Project: 0483-01 - Perris High School No. 4
32255 Leon Road
Winchester, California 92596

Change Order #02-004: Sod vs. Hydro Seed

DESCRIPTION:
CE #283 - Sod vs. Hydro Seed
Landscape revisions as directed in CCD 172: Credit hydro seed and install sod; remove irrigation and install decomposed granite.

Hydroseed to SOD Substitution.

L 3.1
X-778

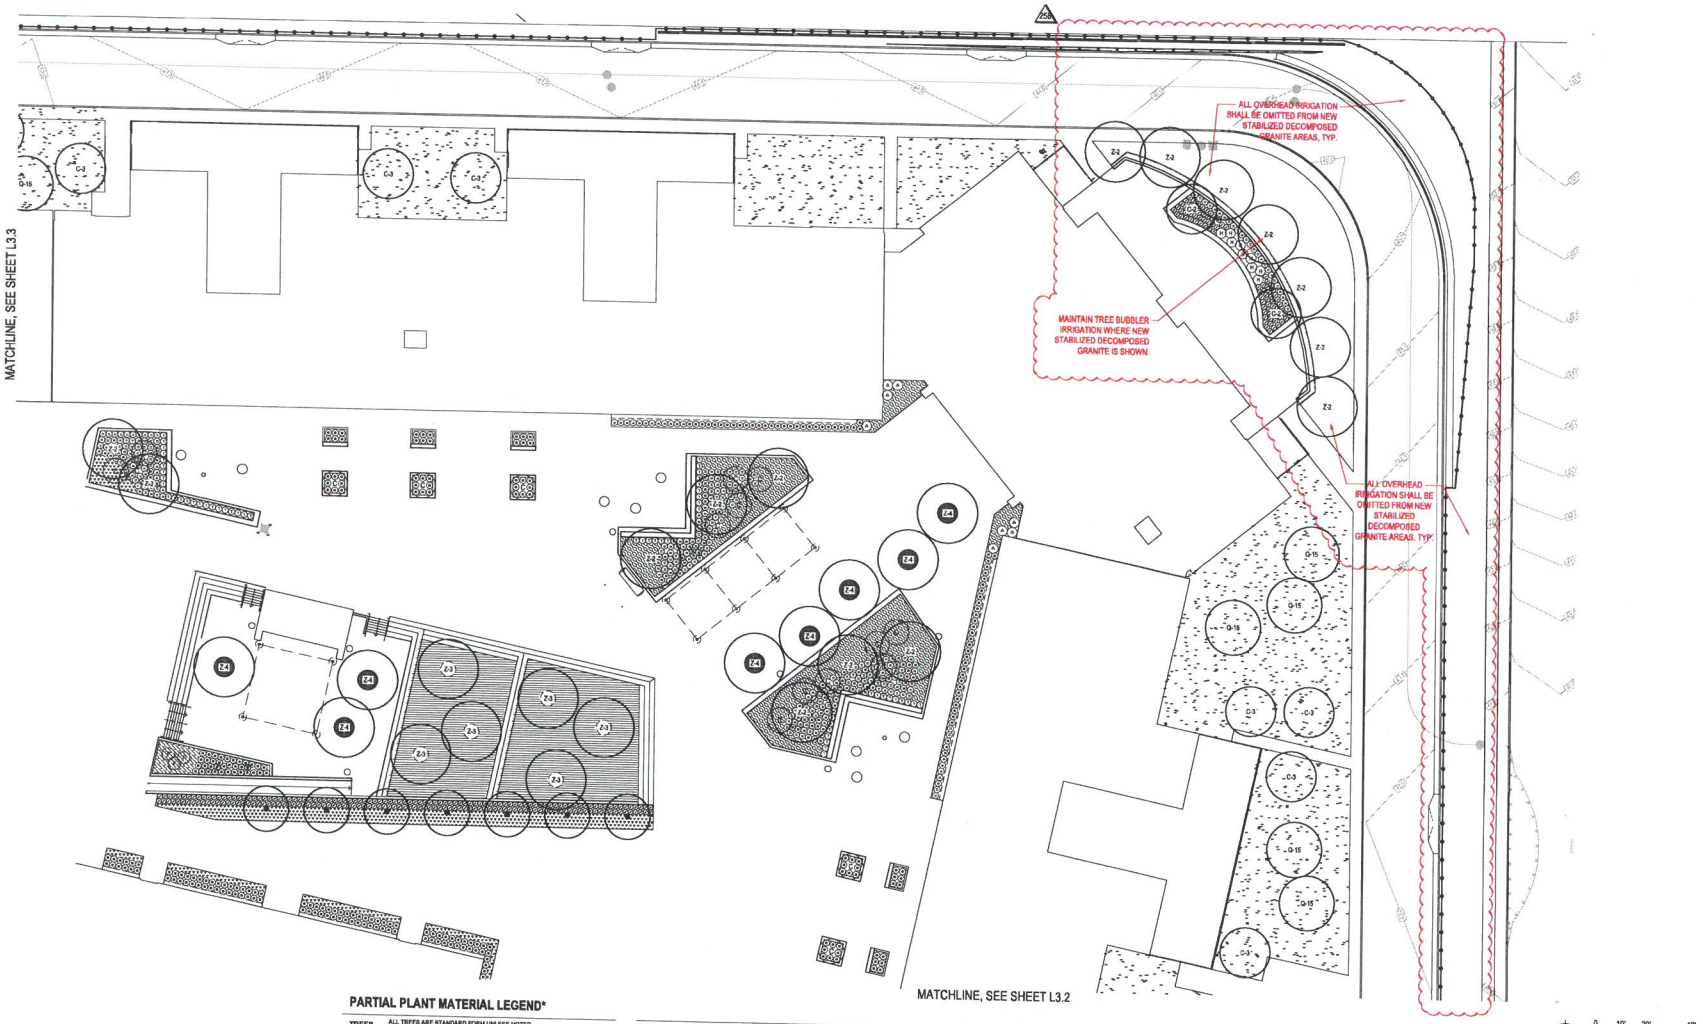
SYMBOL	SIZE	SPACING	BOTANICAL NAME
	1 GAL.	48" O.C.	BACCHARIS P. 'PIGEON POINT'
	~~1 GAL.~~	~~36" O.C.~~	~~MUHLENBERGIA DUBIA~~
	1 GAL.	36" O.C.	MUHLENBERGIA RIGENS
	PLUG	36" O.C.	MUHLENBERGIA RIGENS
	1 GAL.	30" O.C.	DIANELLA 'CASSA BLUE'
	1 GAL.	48" O.C.	LANTANA MONTEVIDENSIS
	1 GAL.	48" O.C.	ROSMARINUS 'HUNTINGTON CARPET'
	1 GAL.	24" O.C.	SENECIO MADRALISCAE
	1 GAL.	18" O.C.	SESLERIA AUTUMNALIS
	~~HYDROSEED TURF~~ OMITTED		
	SODDED TURF - *REFER TO INSTALL LETTER ON DETAIL 9 / L 4.3*

L 3.2
X-779

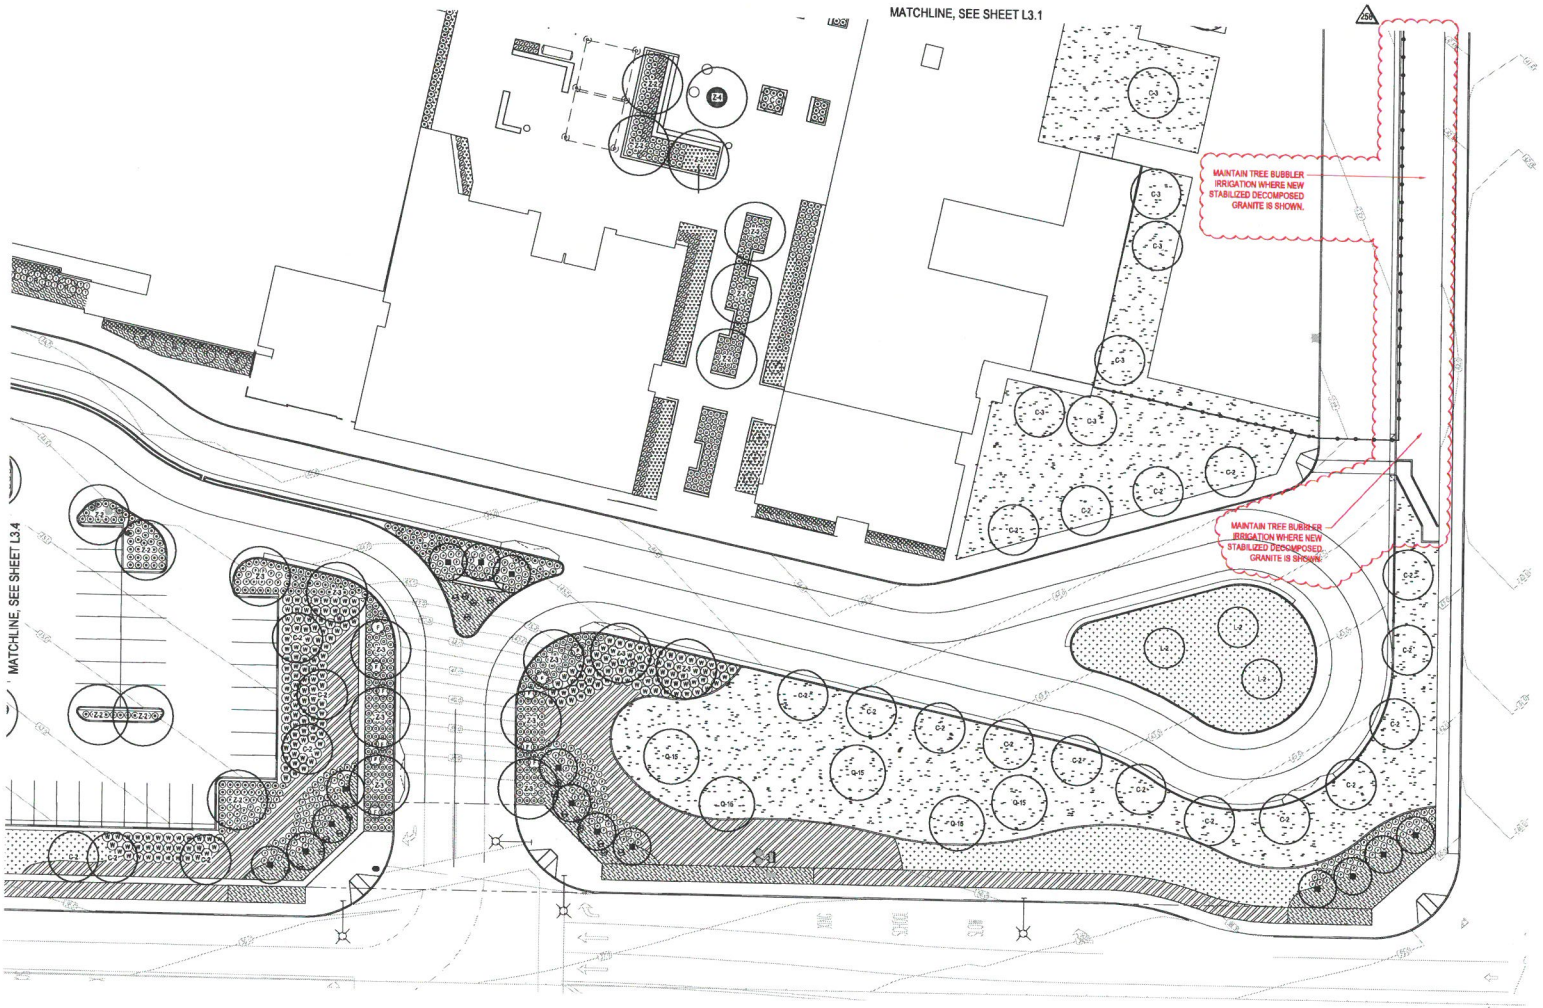
SYMBOL	SIZE	SPACING	BOTANICAL NAME
	1 GAL.	48" O.C.	BACCHARIS P. 'PIGEON POINT'
	~~1 GAL.~~	~~36" O.C.~~	~~MUHLENBERGIA DUBIA~~
	1 GAL.	36" O.C.	MUHLENBERGIA RIGENS
	PLUG	36" O.C.	MUHLENBERGIA RIGENS
	1 GAL.	30" O.C.	DIANELLA 'CASSA BLUE'
	1 GAL.	48" O.C.	LANTANA MONTEVIDENSIS
	1 GAL.	48" O.C.	ROSMARINUS 'HUNTINGTON CARPET'
	1 GAL.	24" O.C.	SENECIO MADRALISCAE
	1 GAL.	18" O.C.	SESLERIA AUTUMNALIS
	~~HYDROSEED TURF~~		~~OMITTED~~
	SODDED TURF - *REFER TO INSTALL LETTER ON DETAIL 9 / L 4.2*

L 3.6
X-780

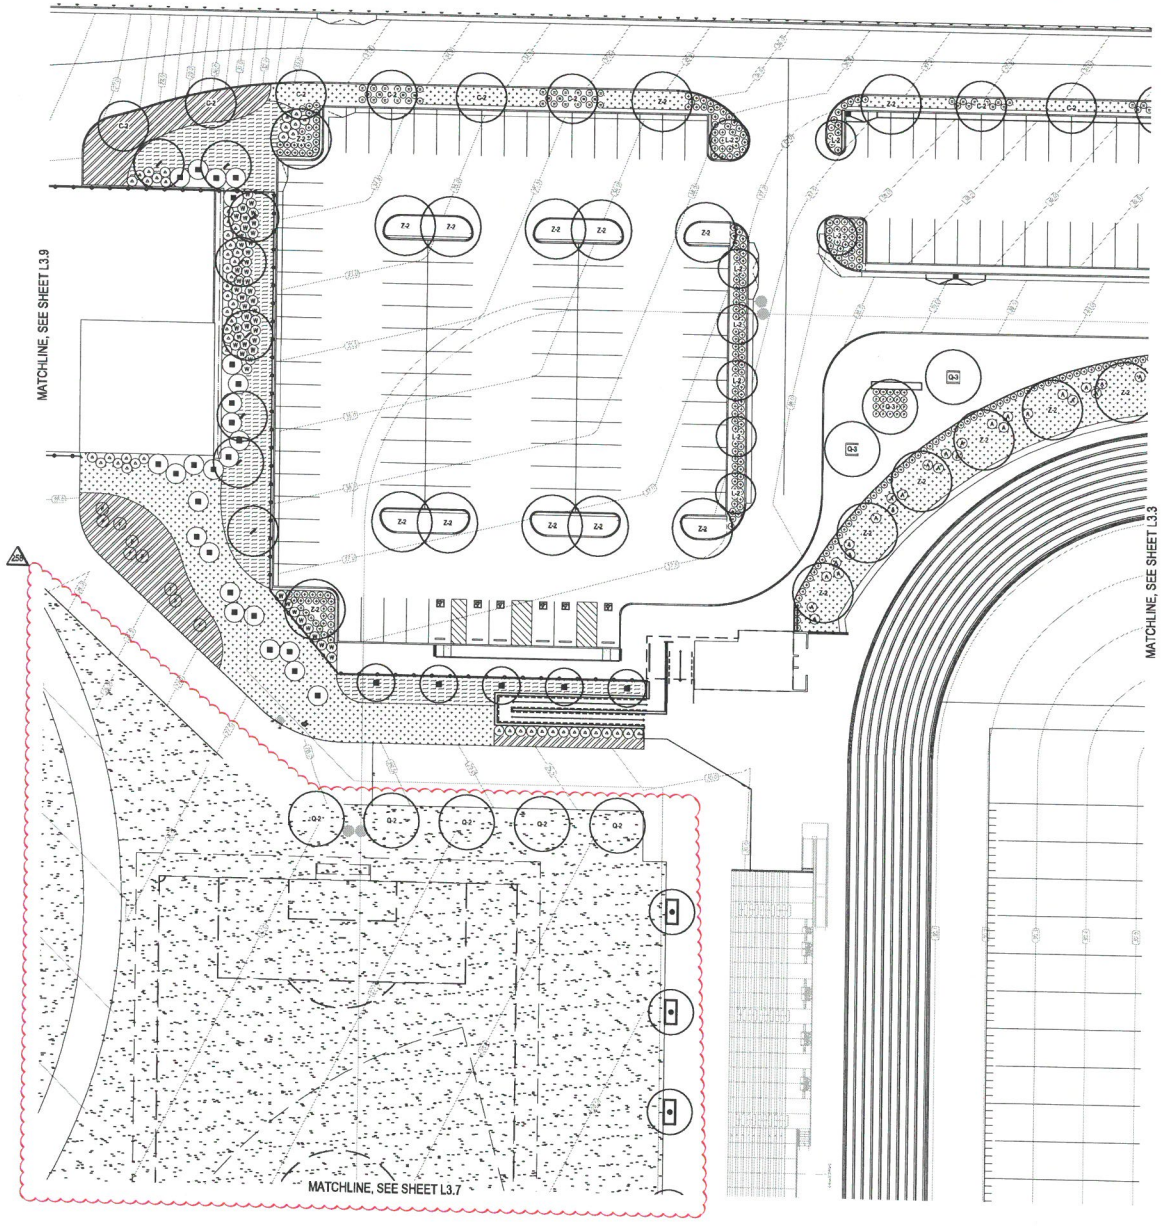
SYMBOL	SIZE	SPACING	BOTANICAL NAME
	1 GAL.	48" O.C.	BACCHARIS P. 'PIGEON POINT'
	~~1 GAL.~~	~~36" O.C.~~	~~MUHLENBERGIA DUBIA~~
	1 GAL.	36" O.C.	MUHLENBERGIA RIGENS
	PLUG	36" O.C.	MUHLENBERGIA RIGENS
	1 GAL.	30" O.C.	DIANELLA 'CASSA BLUE'
	1 GAL.	48" O.C.	LANTANA MONTEVIDENSIS
	1 GAL.	48" O.C.	ROSMARINUS 'HUNTINGTON CARPET'
	1 GAL.	24" O.C.	SENECIO MADRALISCAE
	1 GAL.	18" O.C.	SESLERIA AUTUMNALIS
	~~HYBRID TUFTED TURF~~		OMITTED
	SODDED TURF - *REFER TO INSTALL LETTER ON DETAIL 9 / L 4.2*

L 3.7
X-781

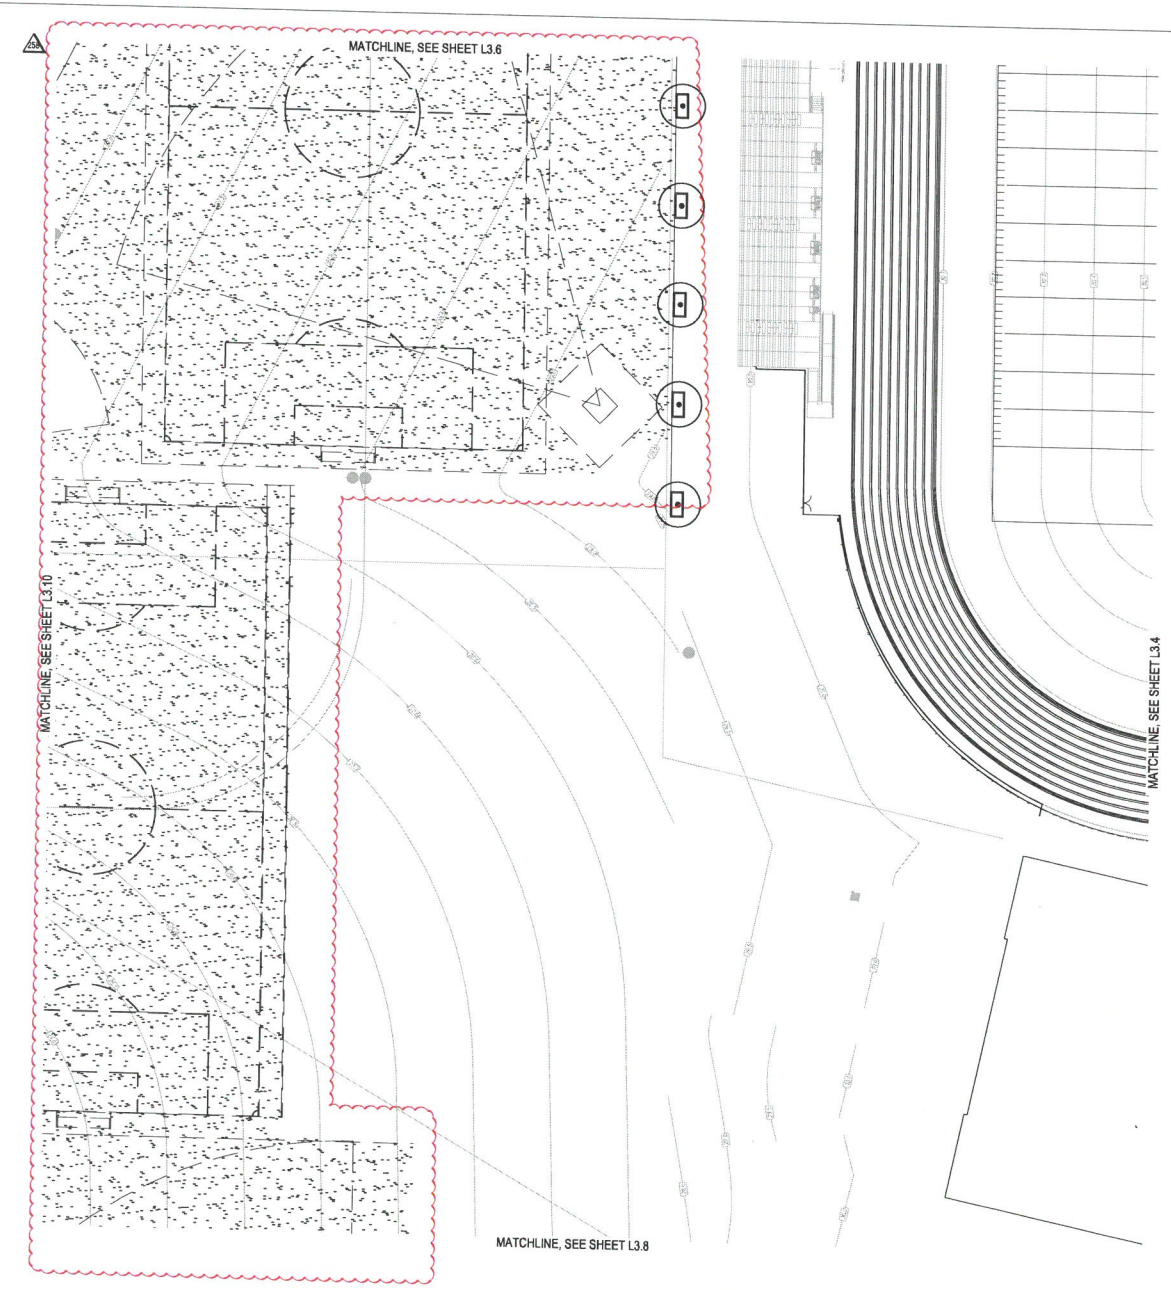
SYMBOL	SIZE	SPACING	BOTANICAL NAME
	1 GAL.	48" O.C.	BACCHARIS P. 'PIGEON POINT'
	~~1 GAL.~~	~~30" O.C.~~	~~MUHLENBERGIA DUBIA~~
	1 GAL.	36" O.C.	MUHLENBERGIA RIGENS
	PLUG	36" O.C.	MUHLENBERGIA RIGENS
	1 GAL.	30" O.C.	DIANELLA 'CASSA BLUE'
	1 GAL.	48" O.C.	LANTANA MONTEVIDENSIS
	1 GAL.	48" O.C.	ROSMARINUS 'HUNTINGTON CARPET'
	1 GAL.	24" O.C.	SENECIO MADRALISCAE
	1 GAL.	18" O.C.	SESLERIA AUTUMNALIS
	~~HYDROSEED TURF~~		OMITTED
	SODDED TURF - *REFER TO INSTALL LETTER ON DETAIL 9 / L 4.2*

L 3.8
X-782

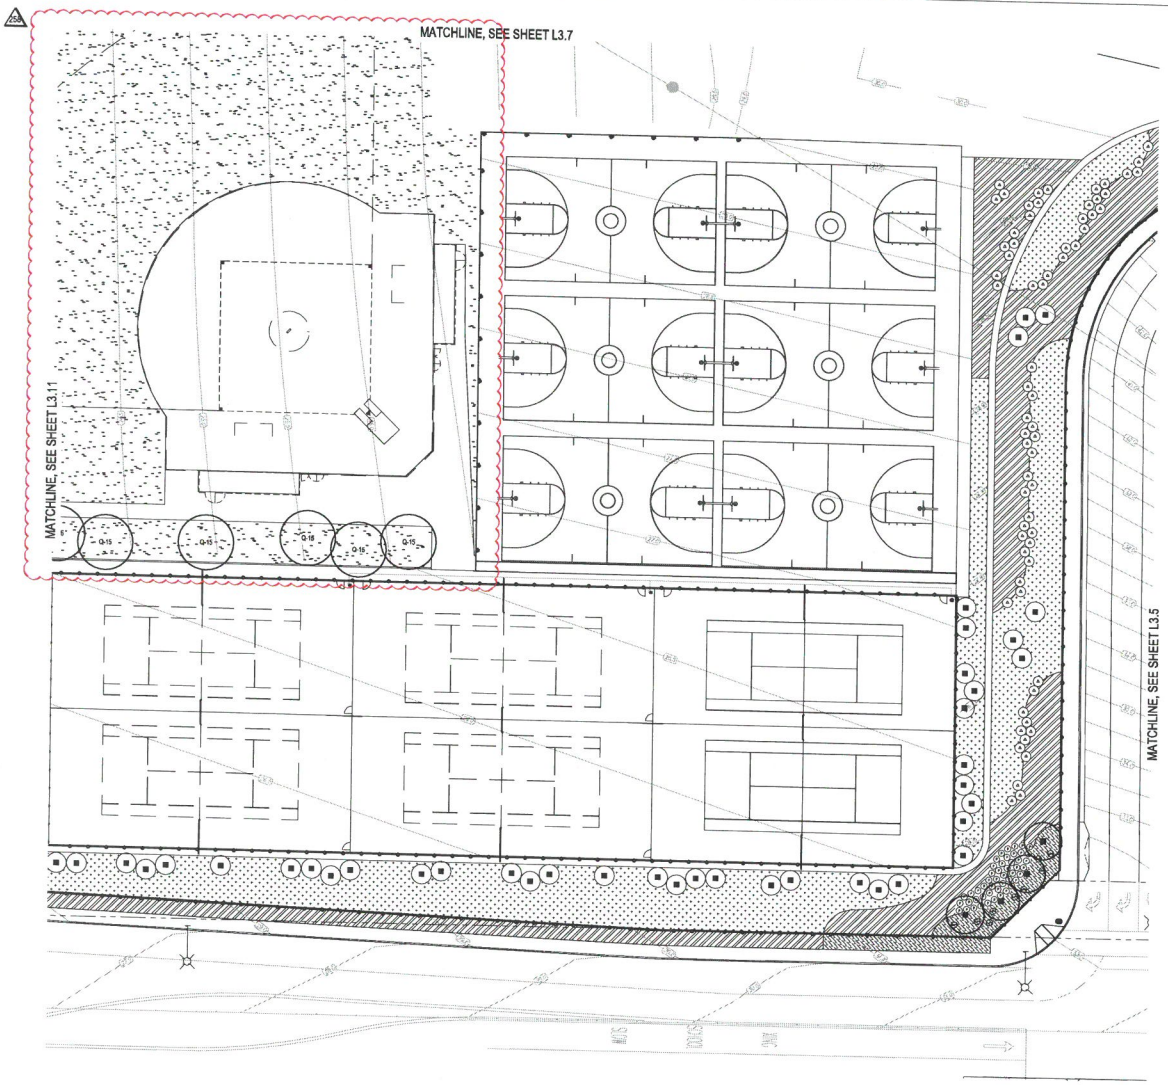
SYMBOL	SIZE	SPACING	BOTANICAL NAME
	1 GAL.	48" O.C.	BACCHARIS P. 'PIGEON POINT'
	~~1 GAL.~~	~~36" O.C.~~	~~MUHLENBERGIA DUBIA~~
	1 GAL.	36" O.C.	MUHLENBERGIA RIGENS
	PLUG	36" O.C.	MUHLENBERGIA RIGENS
	1 GAL.	30" O.C.	DIANELLA 'CASSA BLUE'
	1 GAL.	48" O.C.	LANTANA MONTEVIDENSIS
	1 GAL.	48" O.C.	ROSMARINUS 'HUNTINGTON CARPET'
	1 GAL.	24" O.C.	SENECIO MADRALISCAE
	1 GAL.	18" O.C.	SESLERIA AUTUMNALIS
258	~~HYDROSEED TURF~~ OMITTED		
	SODDED TURF - *REFER TO INSTALL LETTER ON DETAIL 9 / L 4.2*

L 3.9
X-783

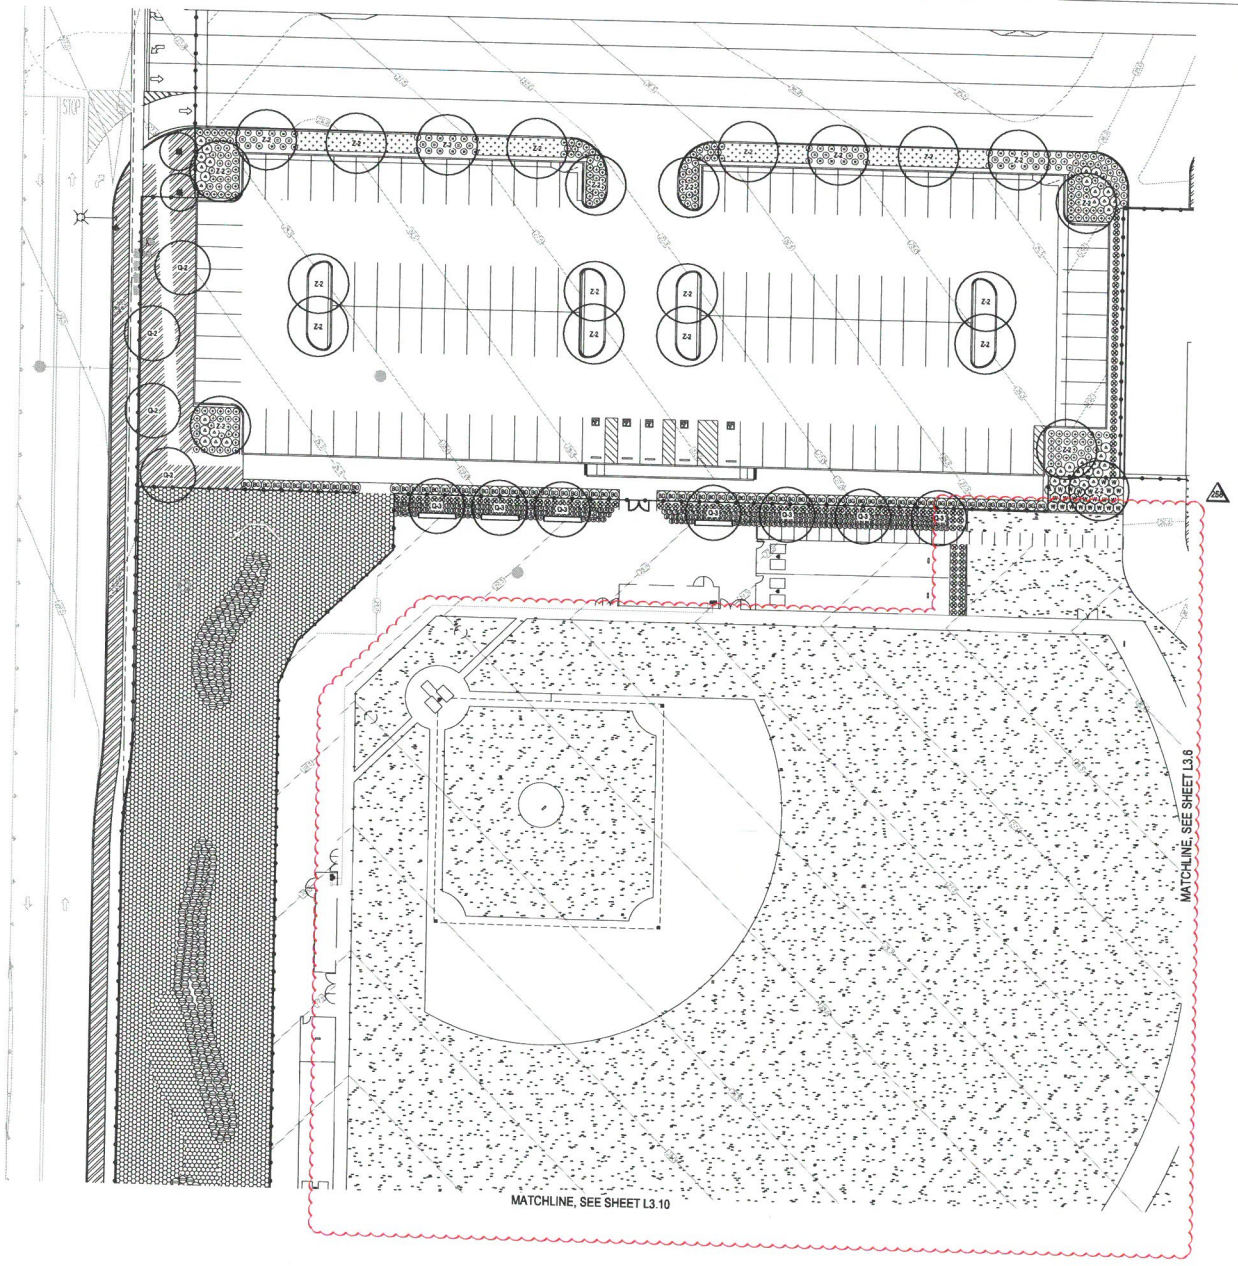
SYMBOL	SIZE	SPACING	BOTANICAL NAME
	1 GAL.	48" O.C.	BACCHARIS P. 'PIGEON POINT'
	~~1 GAL.~~	~~36" O.C.~~	~~MUHLENBERGIA DUBIA~~
	1 GAL.	36" O.C.	MUHLENBERGIA RIGENS
	PLUG	36" O.C.	MUHLENBERGIA RIGENS
	1 GAL.	30" O.C.	DIANELLA 'CASSA BLUE'
	1 GAL.	48" O.C.	LANTANA MONTEVIDENSIS
	1 GAL.	48" O.C.	ROSMARINUS 'HUNTINGTON CARPET'
	1 GAL.	24" O.C.	SENECIO MADRALISCAE
	1 GAL.	18" O.C.	SESLERIA AUTUMNALIS
	~~HYDROSEEDED TURF~~		OMITTED
	SODDED TURF - ***REFER TO INSTALL LETTER ON DETAIL 9 / L 4.2***
